To all FASTRON Customers

Ref no: 000310

Concerning Part Name: SMCC & SMCC/N Series

Product Type: Leaded Inductor {Radial}

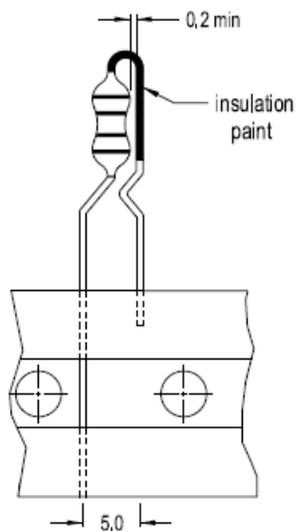
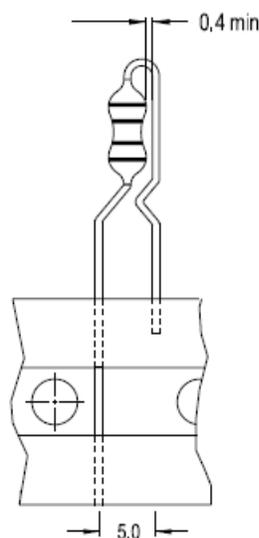
Description of Change: To eliminate the insulation paint on the bent upper lead and change the spacing between the lead and the coil body from 0.2 mm min to 0.4 mm min.
